Design Review and Post-Earthquake Assessment

Horowhenua District Council Building

126-148 Oxford St, Levin

Reference: 2788-8773

Figure 1 Part Plan of roof bracing over Civil Defence headquarters offices

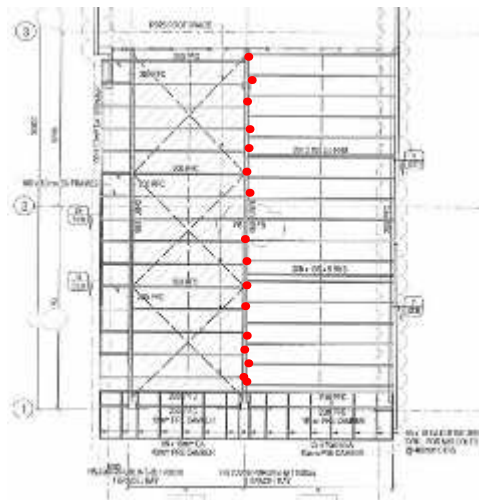
10.01 Roof Bracing Civil Defence offices (Grids A-D and 1-3):

The Tensile Capacity of rod bracing and flexural stiffness of rafters forming the rod bracing above the Civil Defence Offices. These components were assessed to have a score of ~60% of IL2 and <30% of IL4 (Grids A-D). Loads to these elements include the mass of the wall on Grid D. Similar issues apply to the rod bracing over the other offices on Lines 1-3 Grid E-F from the face loaded wall on Grid E)

Figure 2 Part Plan of roof bracing over Council Chamber

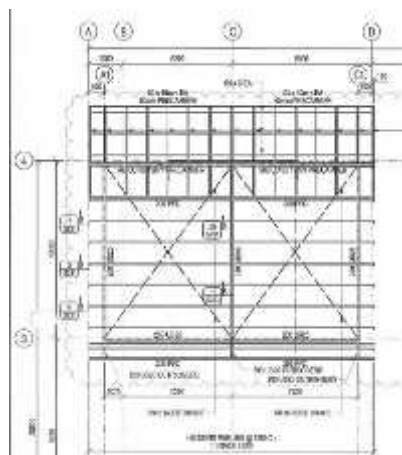
10.02 Lateral Support of Roof over Council Chamber (Grids A-D and 3-4)

Flexural capacity of cantilever posts and face loaded shear wall element above horizontal brace element in flexure estimated in combination at 60% IL2 or 34% IL4.

Figure 3 Partial Roof Plan Over offices lunchroom

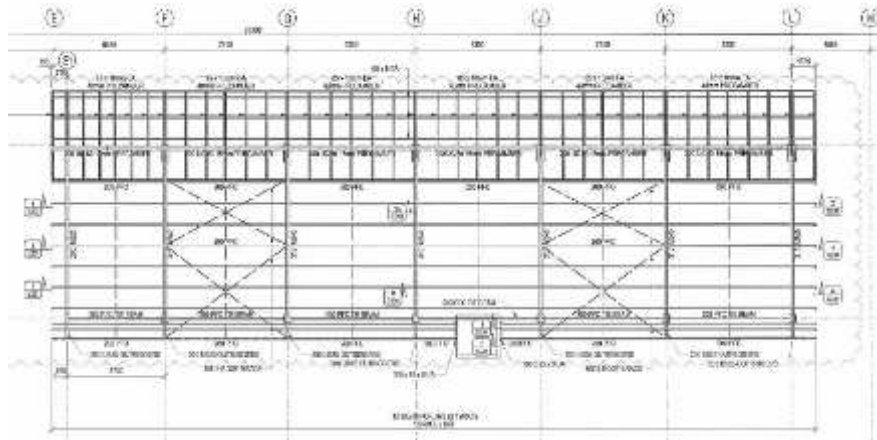
10.03 Roof Bracing over office Lunchroom (Grids E-N and 3-4)

The Tensile Capacity of the rod Bracing and point loads to the rafter causing minor axis flexure to rafters over the office space causing large lateral movement and potential buckling

of the rafter to these areas.

Figure 4 Floor Slab for mezzanine offices.

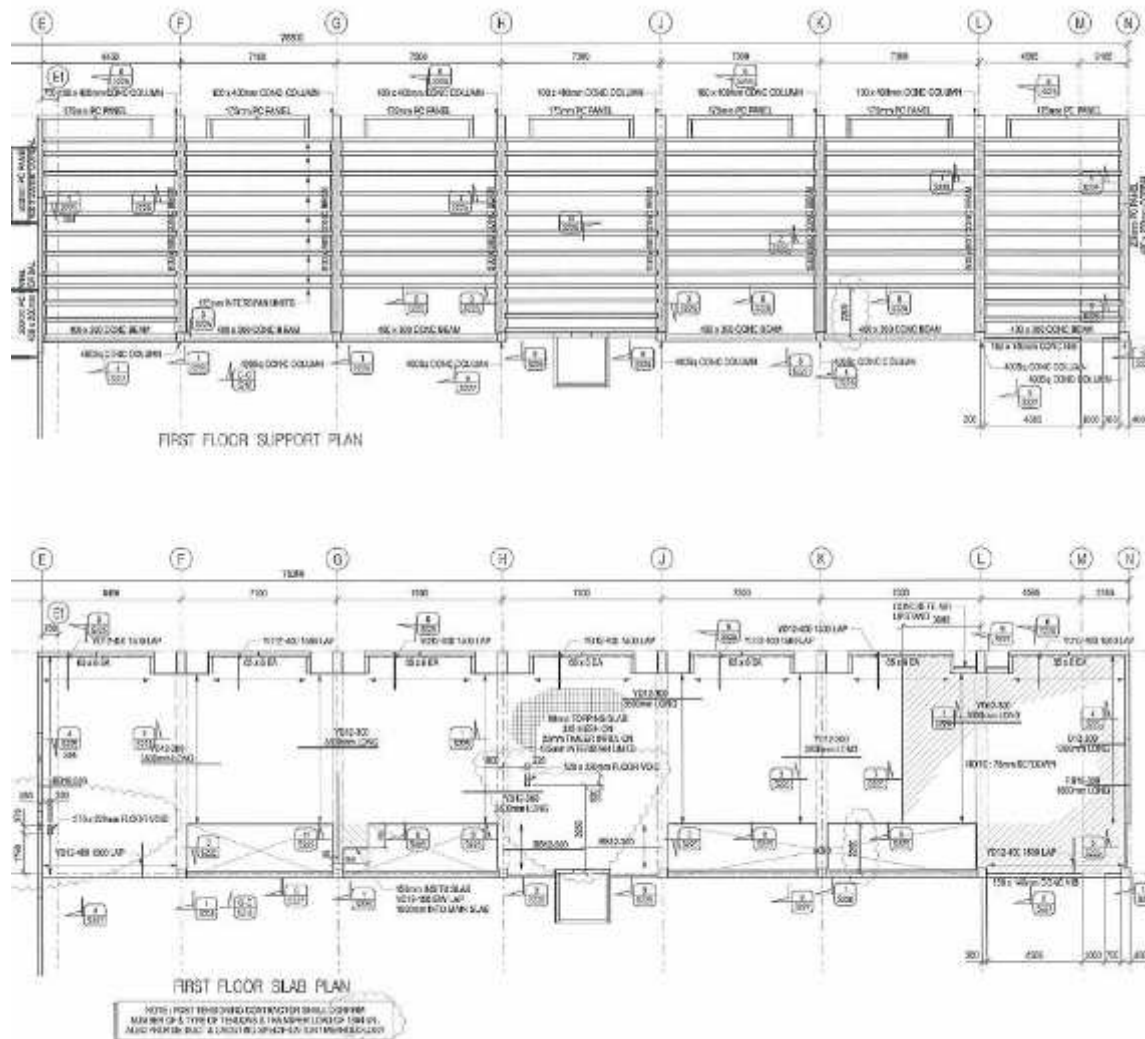
10.04 Floor Diaphragm to offices level 1 (Grids E-N and 3-4)

The building behaviours in this area is very complex, with columns on grid 4 only partially supported by columns below and partially supported on the floor slab system over the basement and loads to these columns being applied and supported in such a way as to create large loads at slab levels. If as per the original design intent the floor system is considered to be supported at lines E and N by shear walls and on lines 3 and 4 by shear walls parallel with Oxford street, it is our opinion that the floor diaphragm will perform poorly, with stress concentrations at corners of opening and in the tie members exceeding the capacity of the reinforcing steel present. When checked as a part under section 8 of NZS1170.5 with the above support assumption this diaphragm has a rating of approximately 35% at IL2 and under 20% at IL4.

The diaphragm for the level 2 offices and lunchroom if lateral support only provided by end walls for horizontal span in flexure have been assessed as ~34% at IL2 or 28% at IL4

Figure 5 Frame at Line G-L

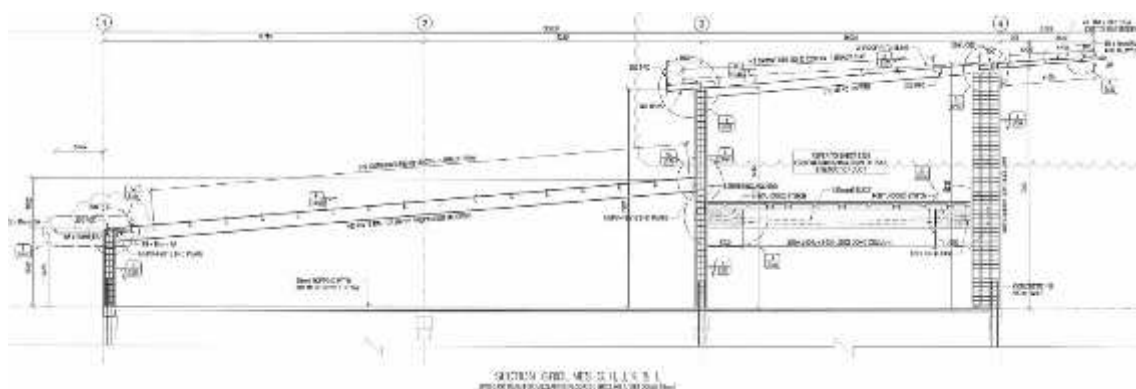
If the concrete frames on lines F-L are used as a partial support in the lateral direction, which is not an unreasonable assumption as there is a nominal moment joint between the column and the precast post tensioned beam at grid 3 the floor diaphragm is no longer the controlling element, but the moment connection at the base of the column now dominates. In this case we have assessed the floor as approximately 50% NBS at IL2 and under 30% at IL4.

If frame action of intermediate frames (Grids E-N) is considered, then this area able to carry lateral loads as fixed base columns in flexure the above system then has an assessed rating of 50% at IL2 and <30% at IL4.

Diagram 1

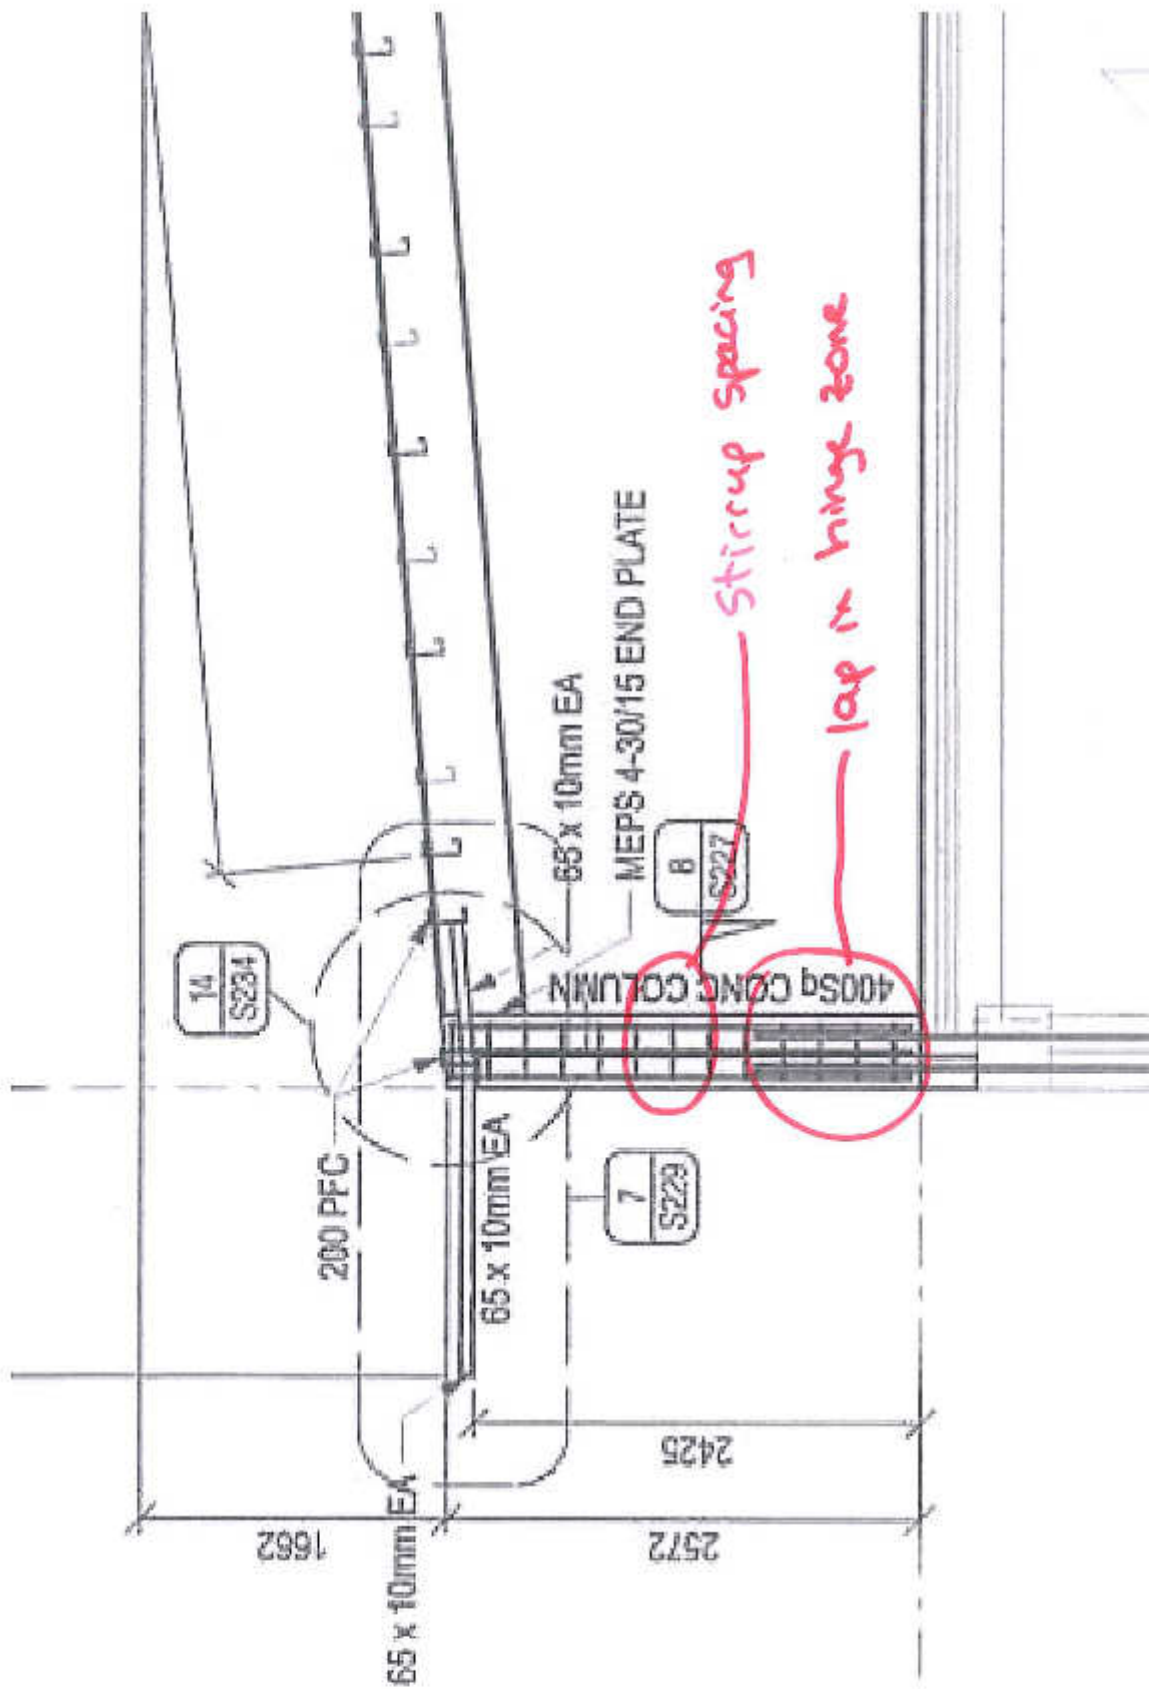
The detailing incorporated on the drawings limit the component ductilities. The upper columns will be restricted to ductilities of 1.25 as the spacing of stirrups is greater than $d/3$, = 120mm, at best, which is a requirement for a ductility of 3 as assumed by the designer. The spacing used is $b/2$ = 200mm. Furthermore no laps can occur in the hinge zone for a ductility of 3 hence the short columns on gridline 1 plus grid C adjacent grid 3 can only assume a ductility of 1.25 at best.

Furthermore the drossbach connection limits the strength as there is less reinforcing at this location. (See Appendix A, Diagram 1, 2, 3 & 4)

Diagram 6

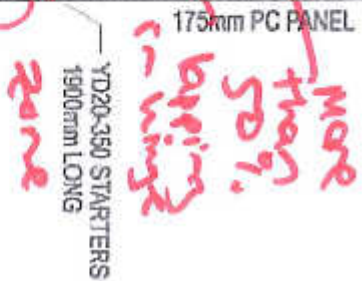
The roof bracing to the chamber area does not engage the central portion of the roof in the north south direction, meaning the load must be resisted by cantilever posts fixed off the inside chord of the horizontal truss and then transfer stresses to a cleat fixed to the concrete panel, or it must span 10m which is generally not normally accepted as good practice. The first option is very flexible and unlikely to provide any significant effect until there is

At present it is more likely the loads get transferred via the roof cladding which would not have been the original design intent. (See Appendix A, Diagram 6, 7, & 8)

Diagram 10

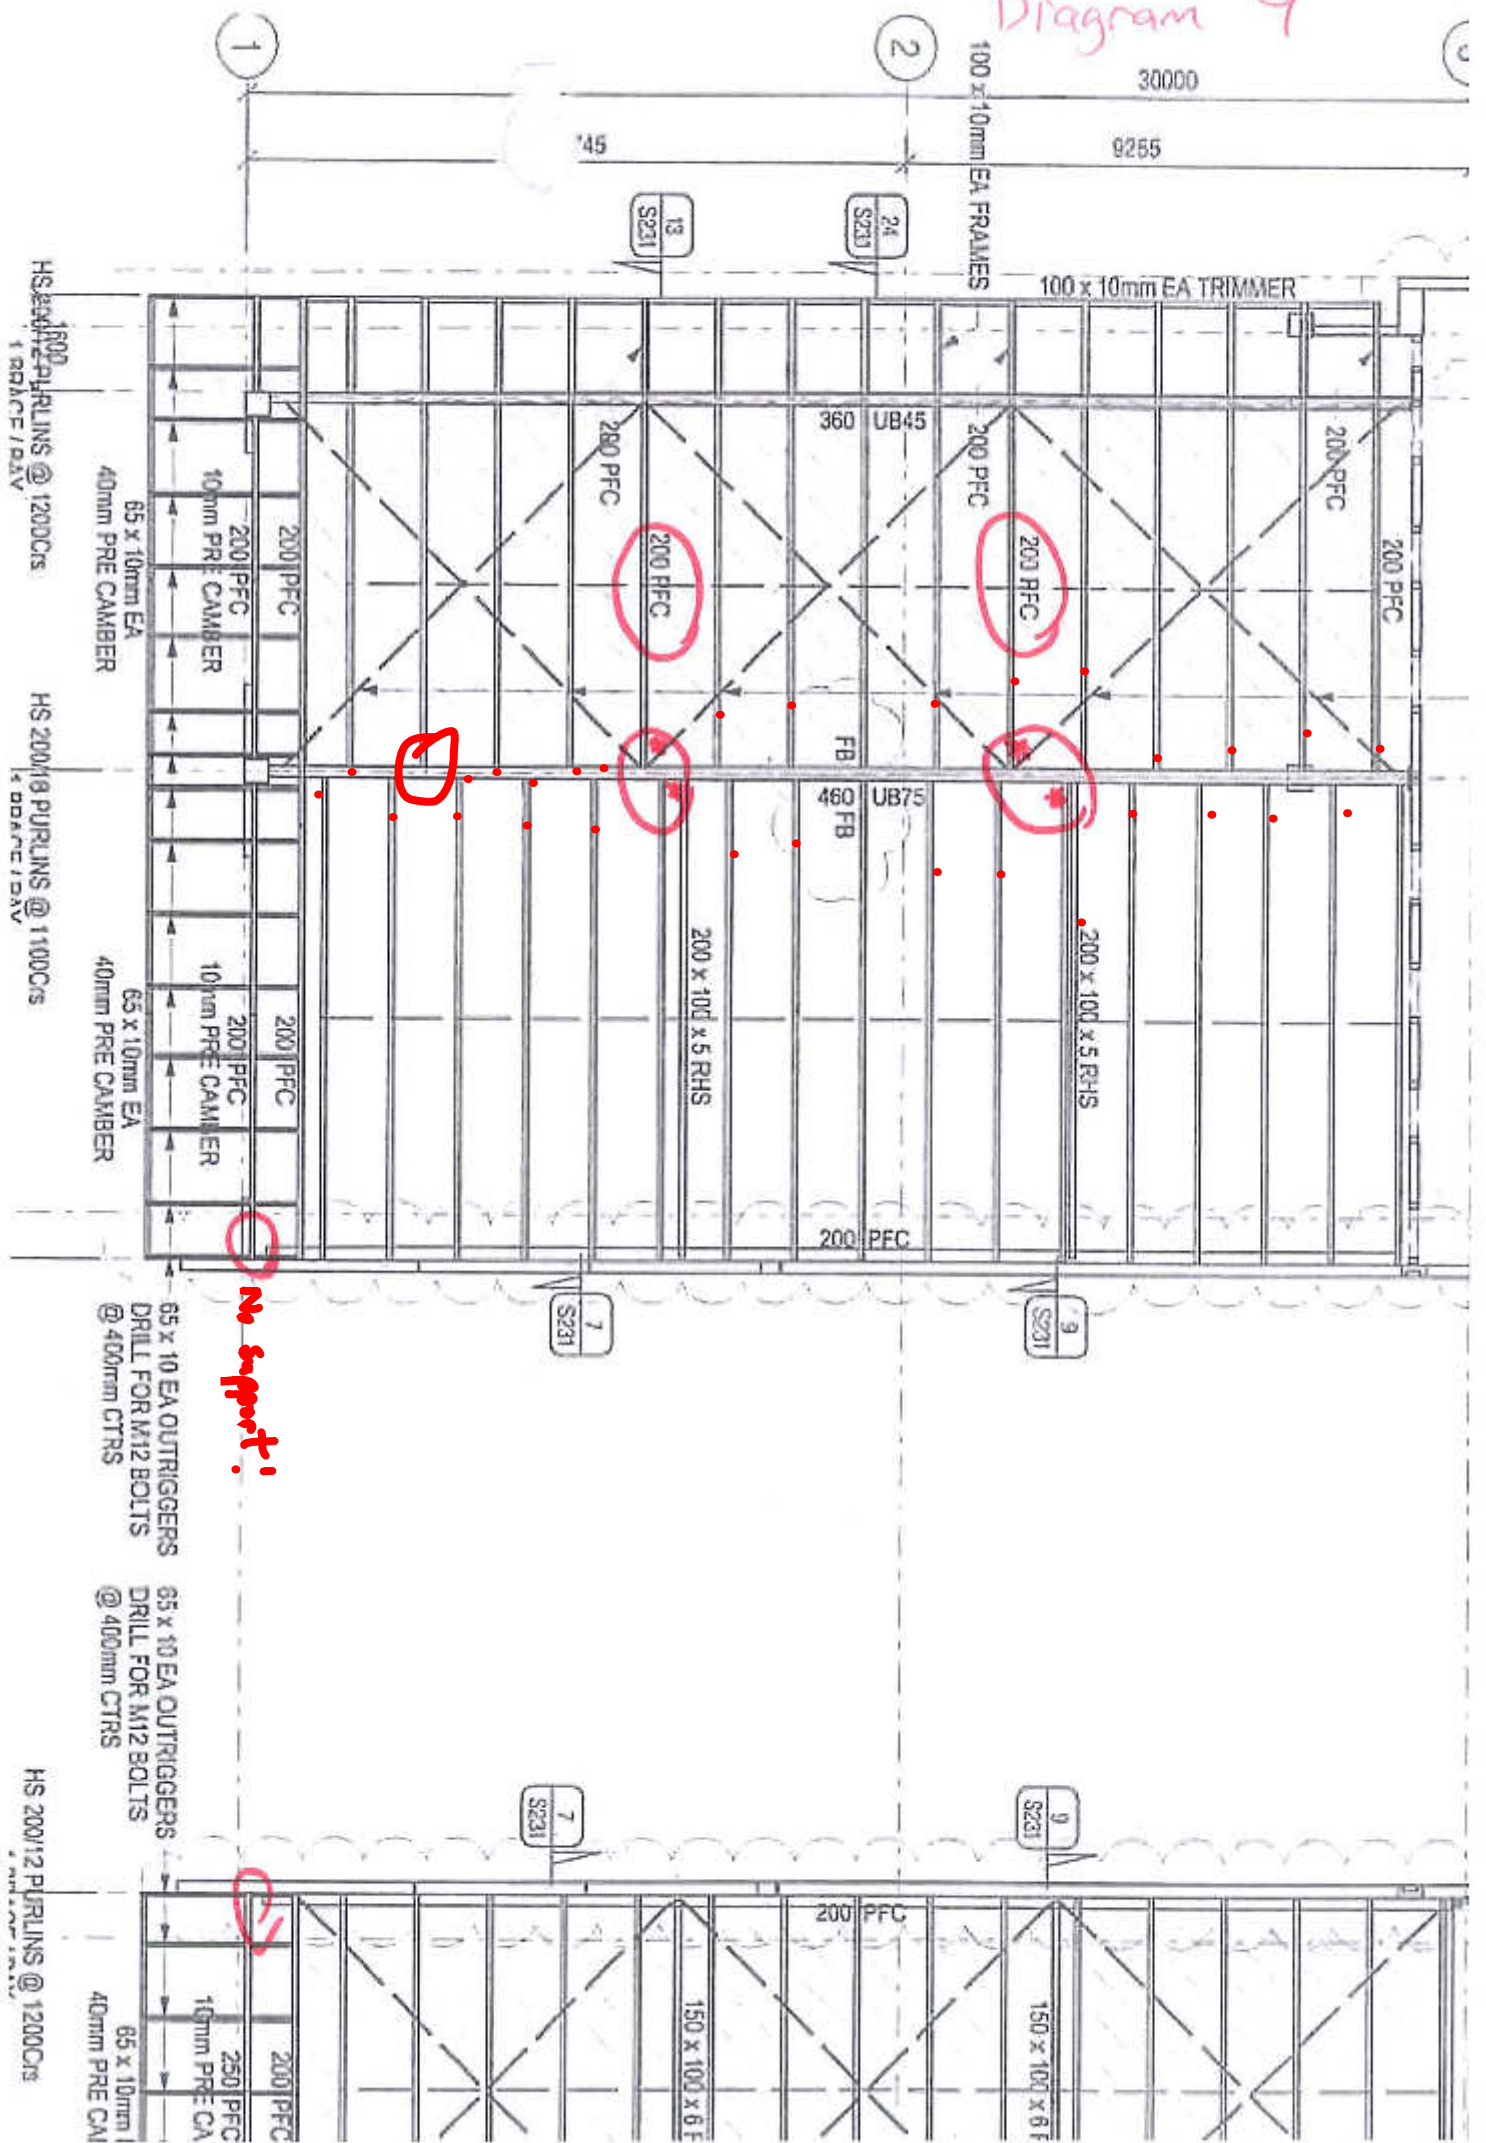
The roof bracing elements adjacent to the foyer precast concrete panels have several detailing issues. Firstly the cleats to the PFC supporting the panels on grid 1 has offset bolts which will not be engaged under tension loads until failure of the bolts closest to the PFC member. This will limit the design capacity. Secondly the struts between grids B & C do not line up with the bracing strut between grid A & B. This will cause unwanted minor axis bending in the main rafter UB limiting the bracing systems strength. Thirdly the struts between grid B & C and grid 1 are PFC members which also limit the capacity of the bracing system. (See appendix A, Diagram 9 & 10)

Diagram 11

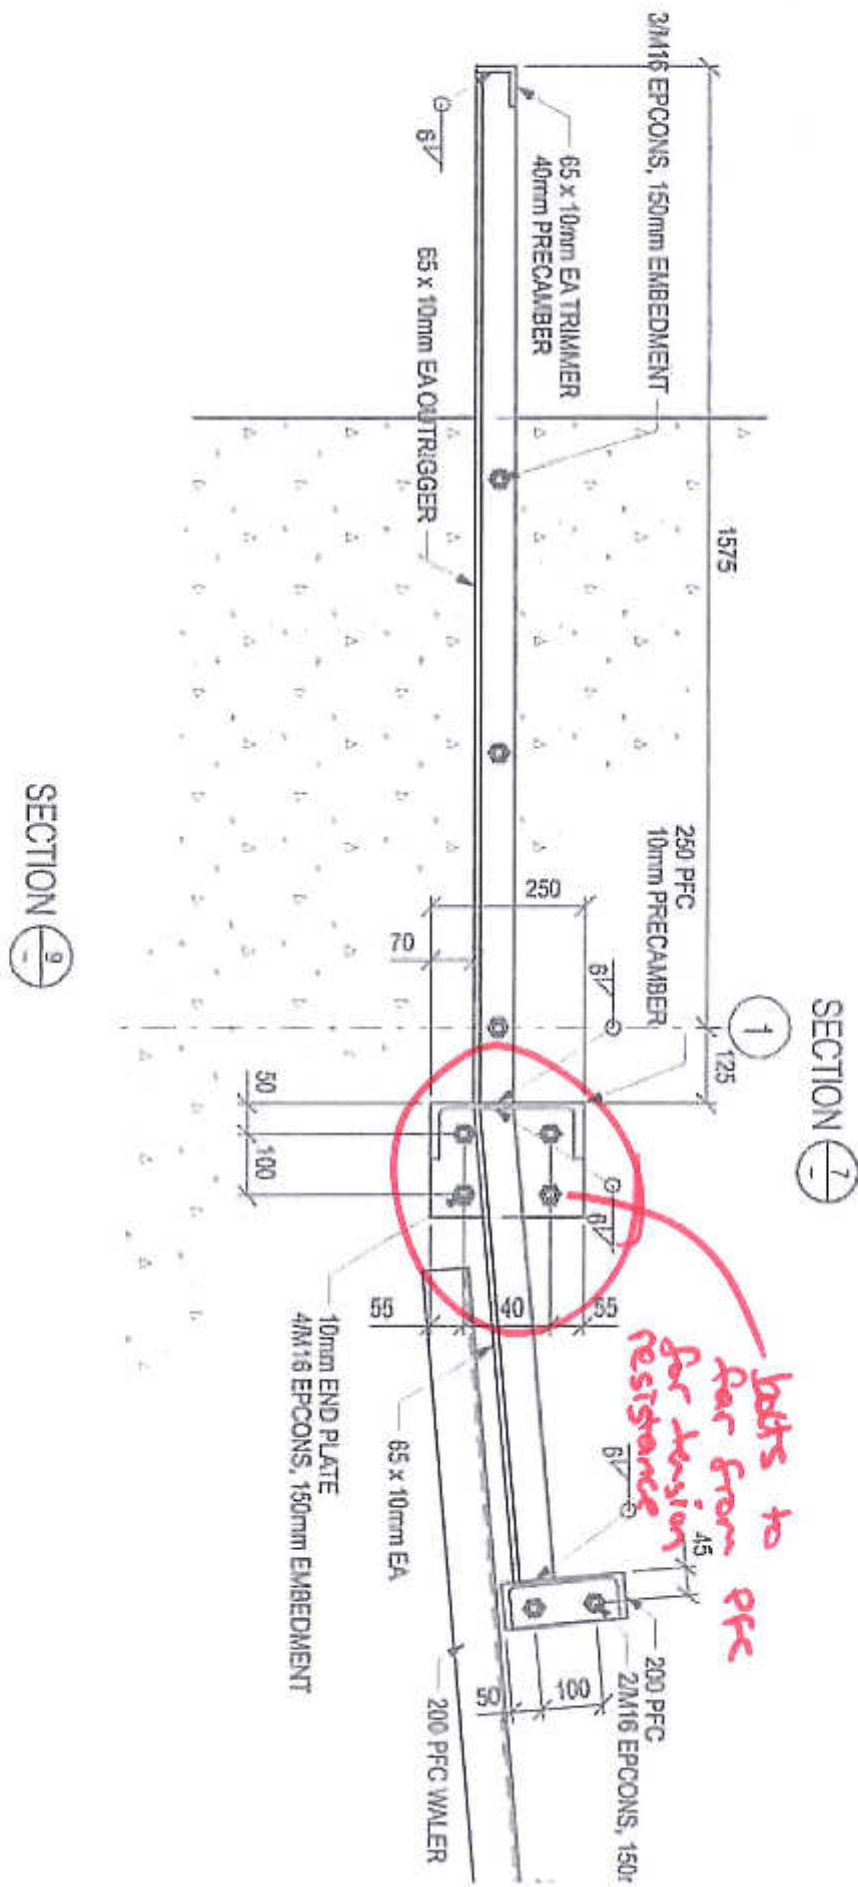
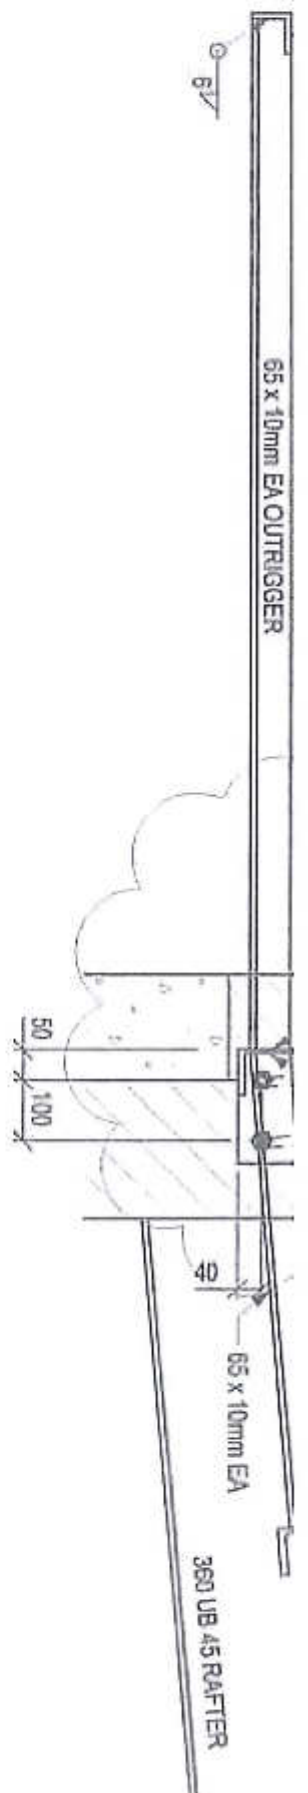
Bar termination at mezzanine floor level of beams to columns does not comply with NZS3101. To engage the joint and provide continuity the bars should extend to the far face of the column and terminate by bending the bar up if it is the bottom bar and down if it is the top bar. The arrangement used will limit the capacity of the reinforcing to be engaged at the joint and therefore capacity at the system to act as a frame. (See appendix A, Diagram 11 & 12)
